# Dealer Service Bulletin

NO.: 7SB001-02-01A

**AFFECTED:** 1995-2000 Rialta motor homes

**SUBJECT:** VW Eurovan Chassis Oil Filter Access Improvement

**5-Cylinder**

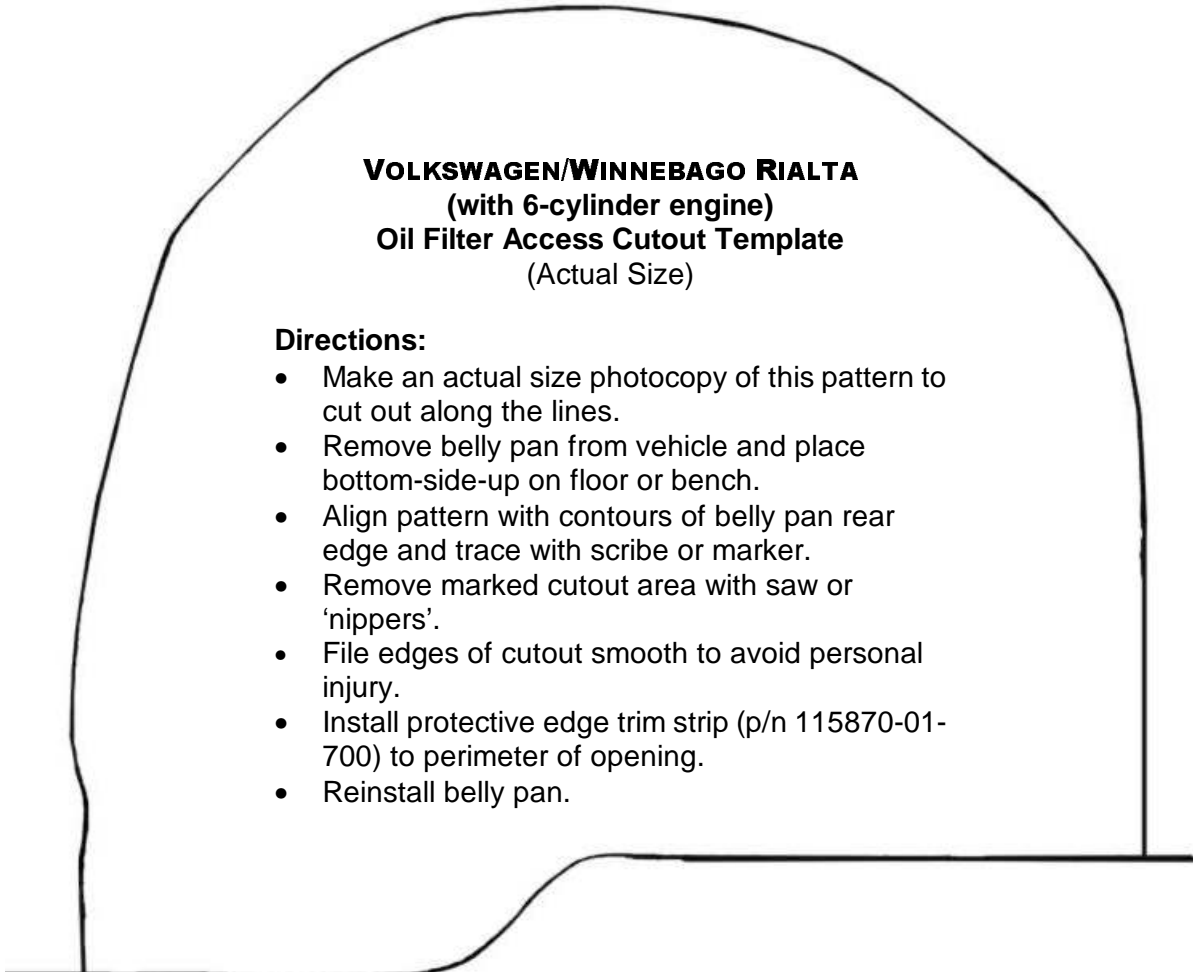
**Modify Belly Pan Attachment Hangers**

The belly pan attachment hinges (hangers) may be modified by bending as shown. This modification allows removal of the swing-down type belly pan by simply jacking the front end slightly, without having to raise the vehicle on a hoist.

- Remove belly pan from vehicle and place bottom-side-down on floor or bench.
- Use pliers or other gripping tool to change the angle of both attachment hangers to 45° as shown on template at end of bulletin.
- Reinstall belly pan.
